**SUBJECT: NEW VEHICLE DELIVERY HOLD - Customer Satisfaction Program 19B42**  
Certain 2020 Model Year Transit Vehicles With All Wheel Drive and Rear Climate Control  
Rear Heater Coolant Lines Inspection and Repair

**NEW VEHICLE DELIVERY HOLD - Customer Satisfaction Program 19B42**  
Certain 2020 Model Year Transit Vehicles With All Wheel Drive And Rear Climate Control  
Rear Heater Coolant Lines Inspection and Repair

## CERTAIN 2020 MODEL YEAR TRANSIT VEHICLES WITH ALL WHEEL DRIVE AND REAR CLIMATE CONTROL — REAR HEATER COOLANT LINES INSPECTION AND REPAIR

FIGURE 2

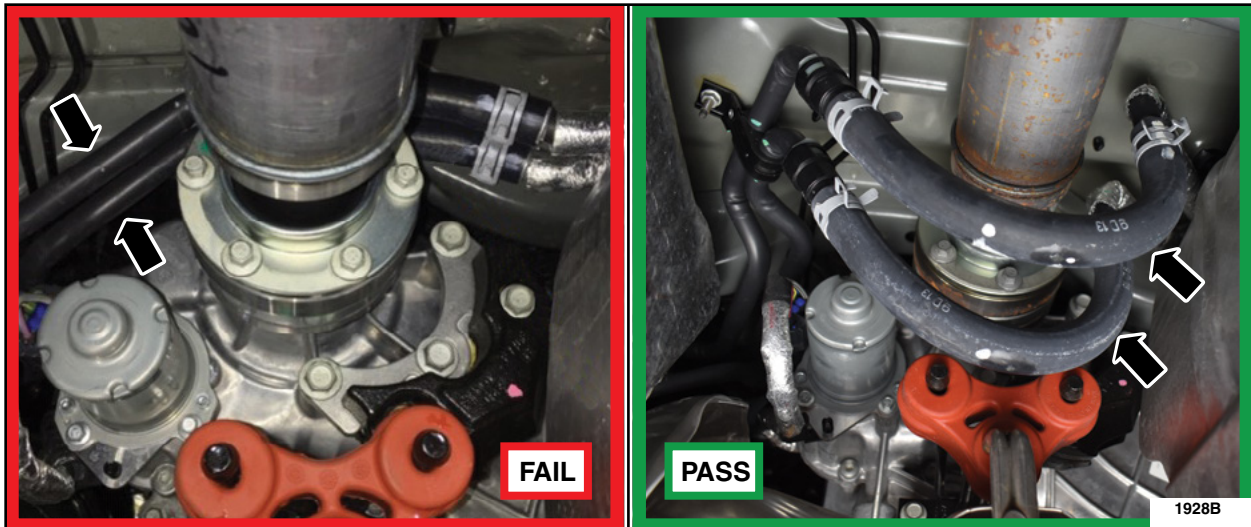
3. Inspect the rear heater coolant lines. See Figure 2.

- Are the rear heater coolant lines routed above or below the drive shaft?

Above - **Fails inspection.** A repair is required but not yet available. Parts are expected to be available by the end of February, 2020. **(Program remains open)**

Below - **Passes inspection.** No further action is required. **(Closes program)**
